IEEE P802.3bt D2.0 4-Pair PoE Initial Working Group ballot comments

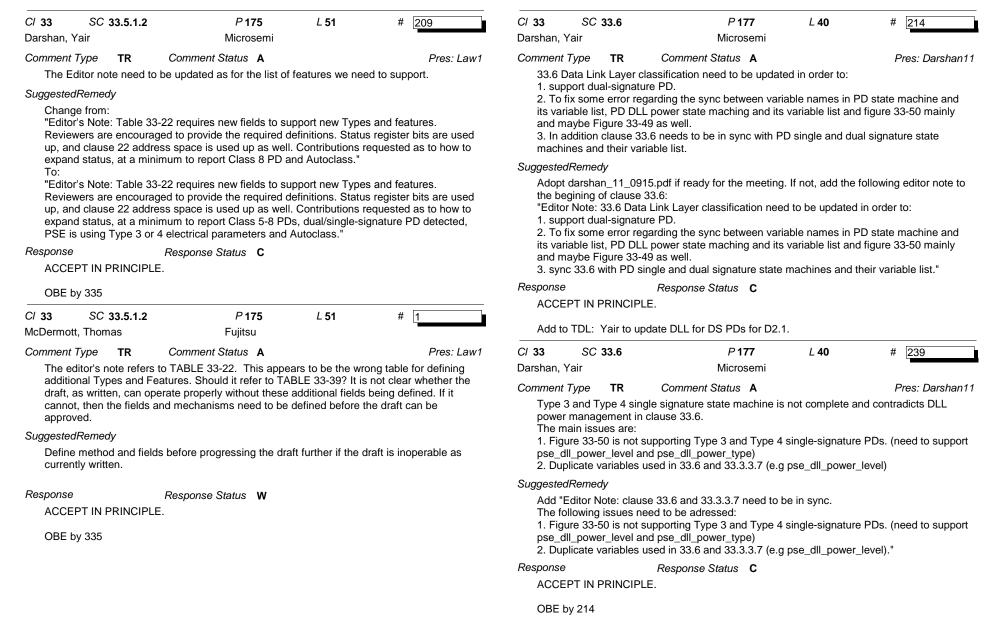
The Editor's note highlights a technical incompleteness that should have disqualified the draft from progressing to WG ballot. While it is admirable to highlight input being needed from WG members, this should have been done prior to ballot.

Unfortunately, I don't think I have a solution for you, but you need one prior to the next recirculation. All that occurs to me is to deprecate the use of Clause 22 registers, require the use of Clause 45 registers (possibly including the mapped Clause 22 registers, and get the extra registers and bits in the Clause 45 register space.
